24/00560/HYB – LAND SOUTH OF STATION ROAD, MARKET BOSWORTH

ADC Infrastructure Limited are commissioned by the applicant, Miller Homes, to provide transport and highways advice in support of a hybrid planning application for the construction of 138 residential dwellings and 0.55ha of employment use on land to the south of Station Road in Market Bosworth. The planning application was supported by a Transport Assessment and Travel Plans.

This letter has therefore been produced to present the updated vehicle tracking assessment and traffic calming features proposed to ensure suitable design speeds throughout the development.

ADC3326-DR- 004

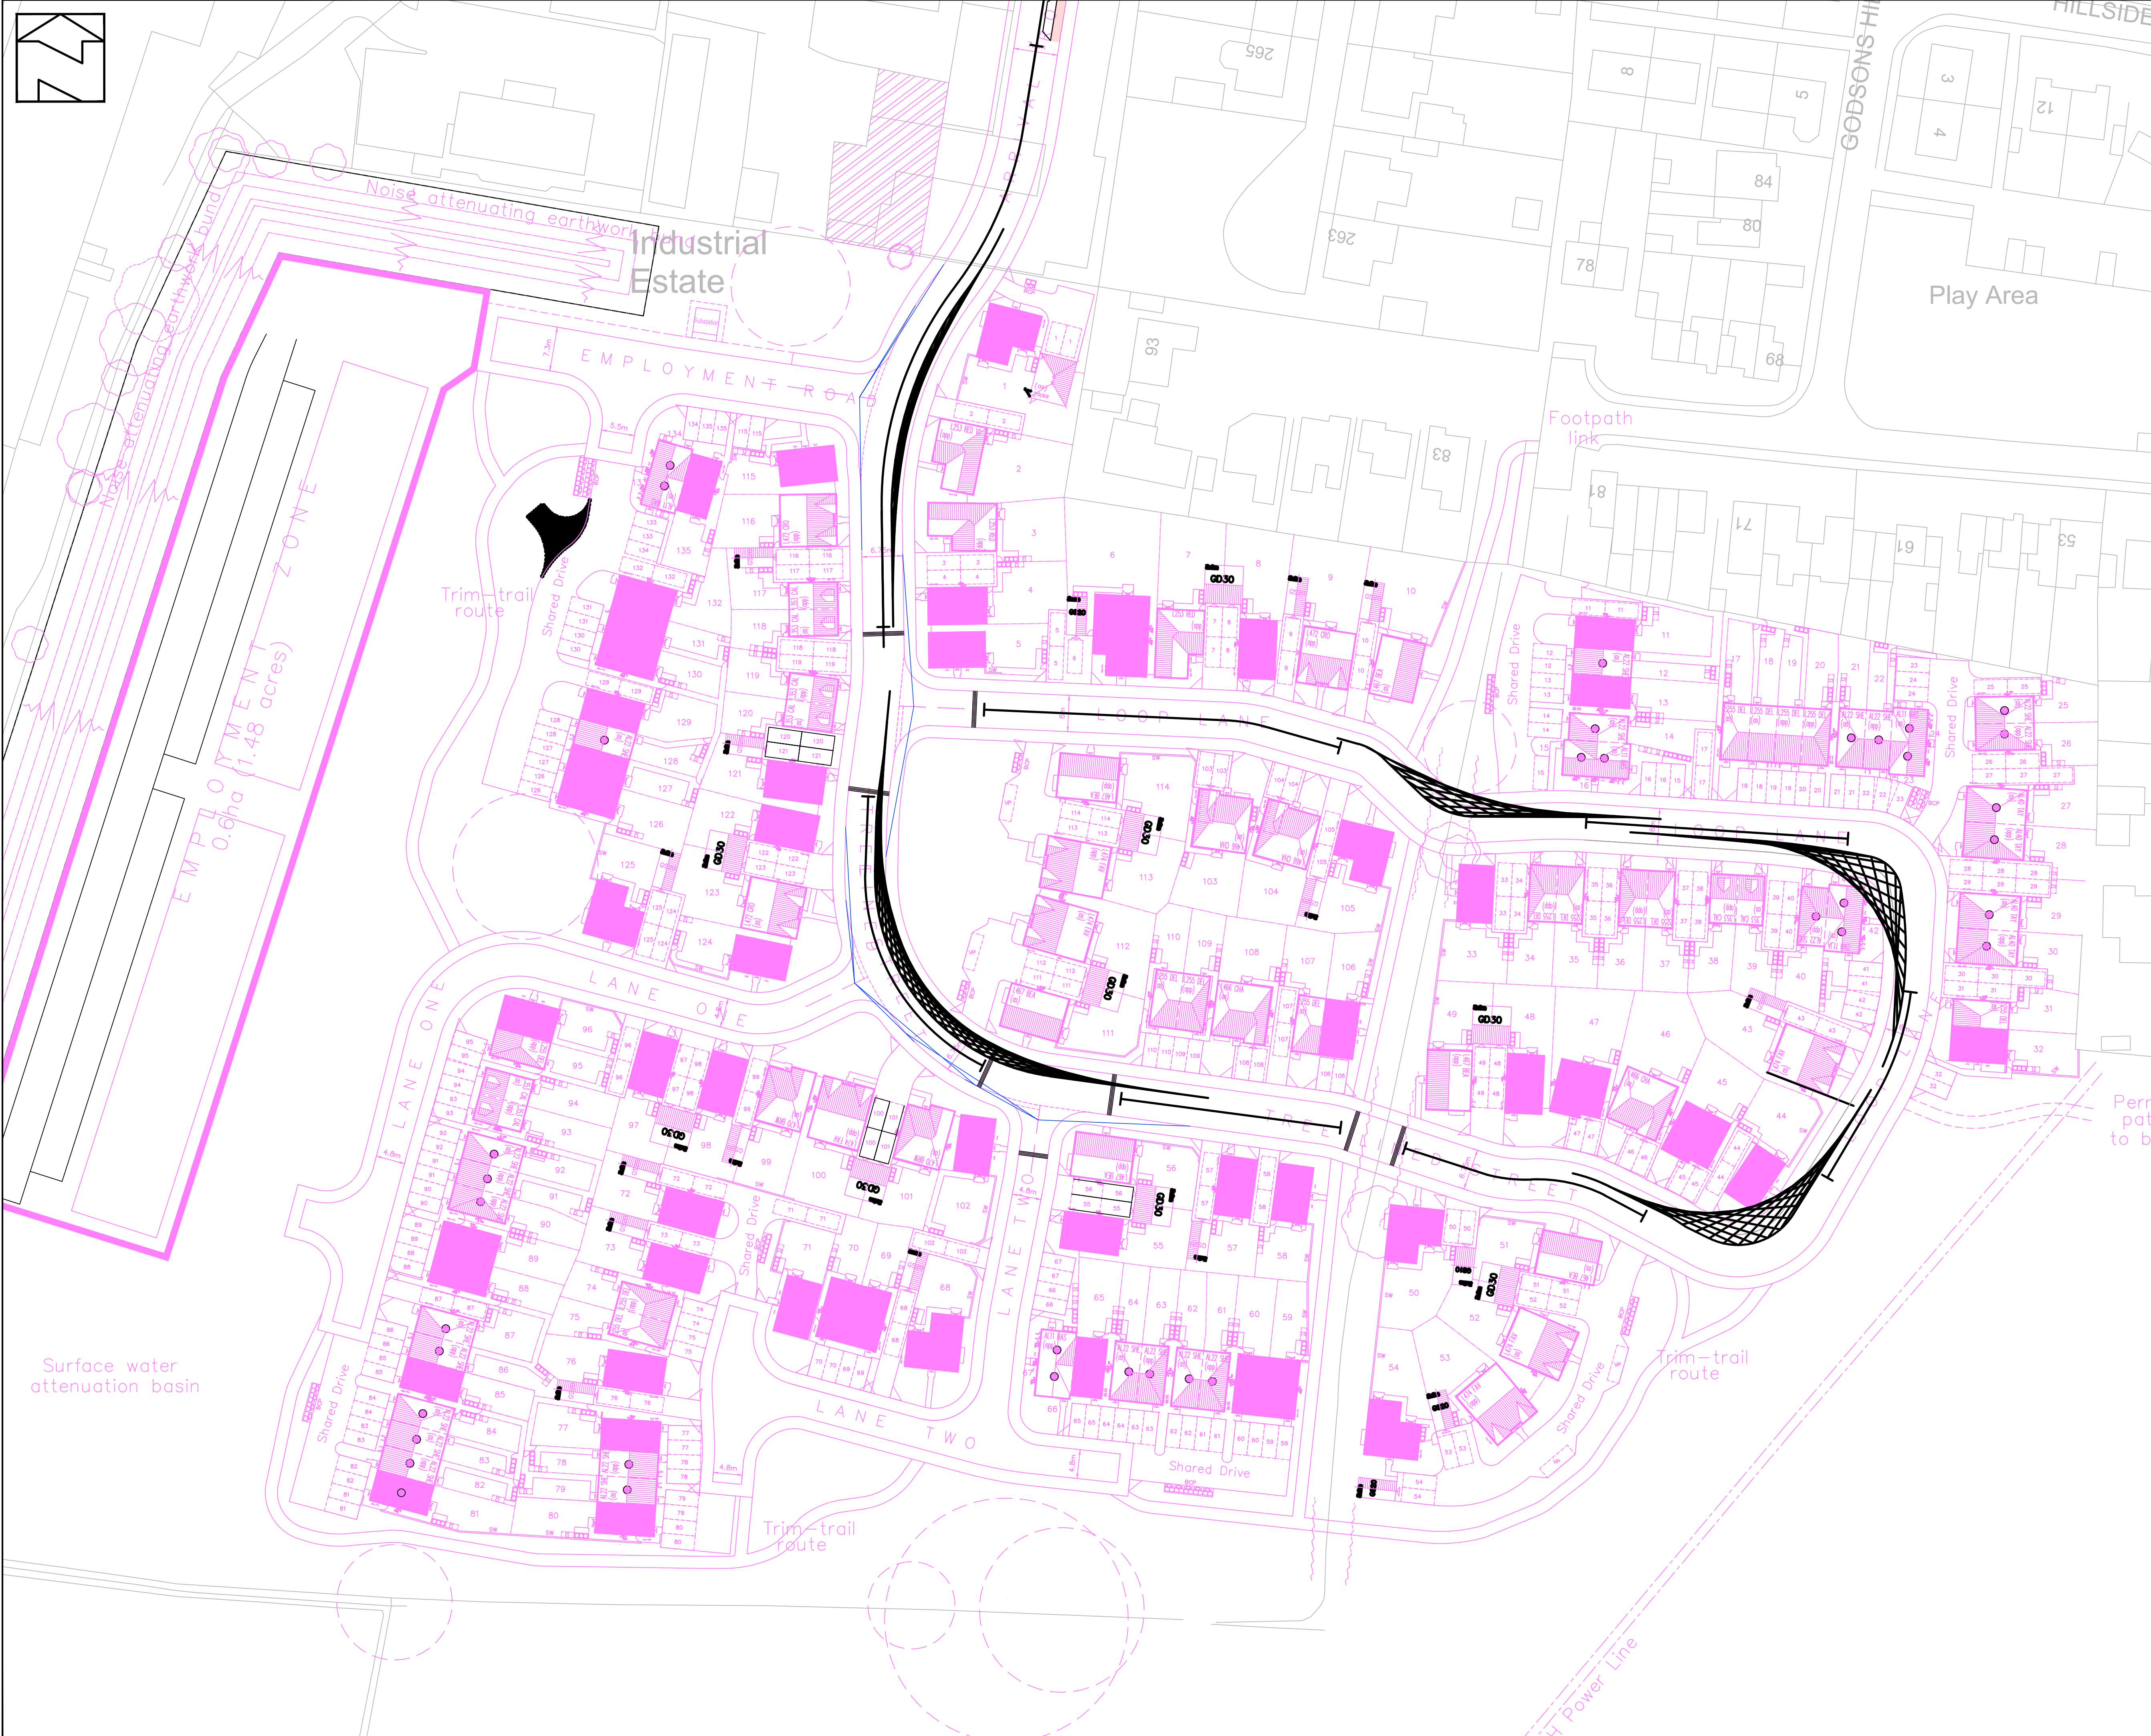
- Speed control is not in accordance with Table 20 of the LHDG and the LHA does not accept the arguments raised in the TN. The width of the road and the excess straight-line distance would likely lead to an increase in vehicle speed, therefore the applicant has not demonstrated how a 20mph design speed will be achieved.

- Visibility splays should be in accordance with Table 6 of the LHDG and appropriate for the design speed of the roads. The LHA would direct the applicant to the visibility splays set out in Table 4 and ask that forward visibility on the 6.75m wide Tree Lined Street is clarified.
- Vehicle accesses should be located at least 10m from the radii of a junction to avoid conflict with turning vehicles and crossing points. Remaining plots with vehicle accesses within 10m of a junction are noted. LCC will request a safety audit on submission of S38 drawing pack.

- The visibility splay looks to go over a tiny bit of third party land
- Changes will be needed to the swept path for refuse vehicles – it looked like the wrong size of vehicle had been used. This might affect the road layout and plot positions
- Traffic calming needed improving
- There remains an issue with the railway station access

Drawing ADC3326-DR-004-P6 presents the traffic calming features and distances between each feature within the development. As shown, a kerb build out with cycle bypass is provided on the site access carriageway. Further south, there are raised tables at the loop lane and lane two junctions. There is a further speed control raised table east of lane two before two 90 degree bends at Plots 40 and 44 and a “S” bend on loop lane outside of Plot 105.

In accordance with the design speeds, **Drawing ADC3326-DR-004-P6** demonstrates that suitable junction and forward visibility splays can be achieved within the development.
